19-021MPR – 56 FRANKLIN STREET

Request

Request for review and approval for modifications to a previously approved garage.

Planning staff recommends approval of a Minor Project Review with no conditions.

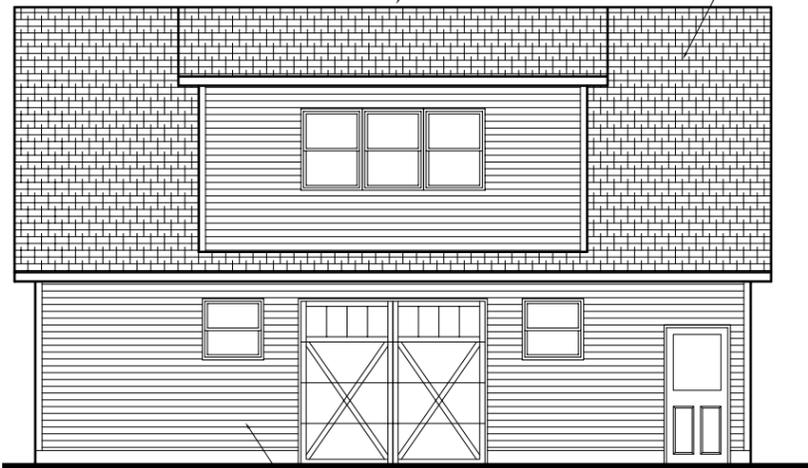
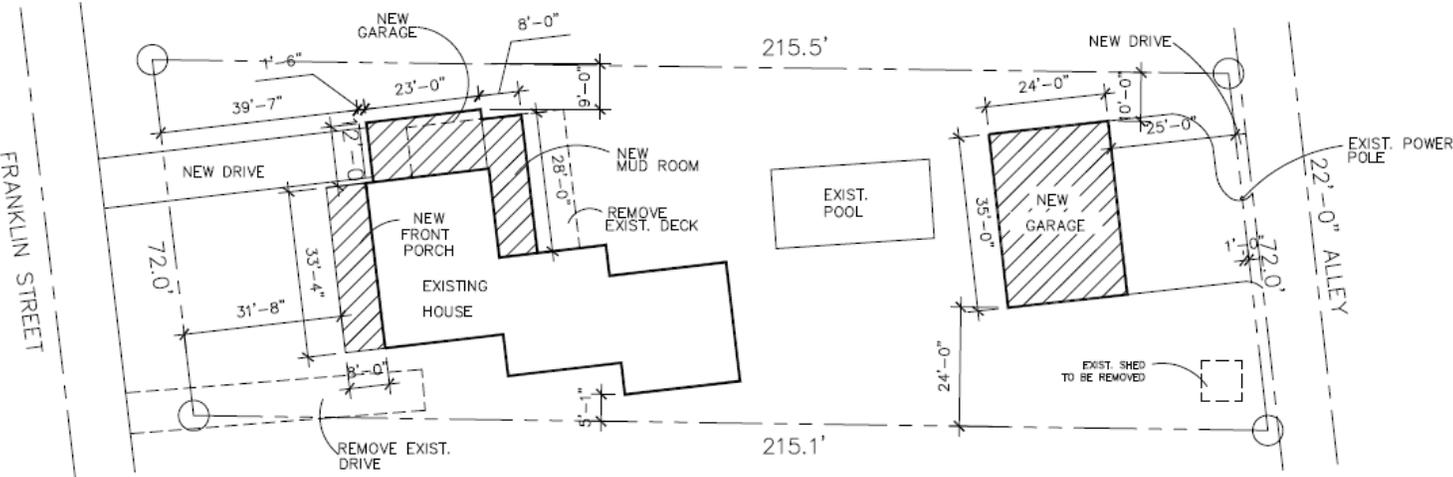
The applicant is proposing to add two new windows on the west façade (in addition to the dormer), as well as two single windows on the north and south facing façades. The windows on the western side of the garage are located on either side of the garage door.

The applicant is proposing to relocate a door on the west elevation from center to the southern portion of the façade. This change is to accommodate the addition of a staircase to the second story.
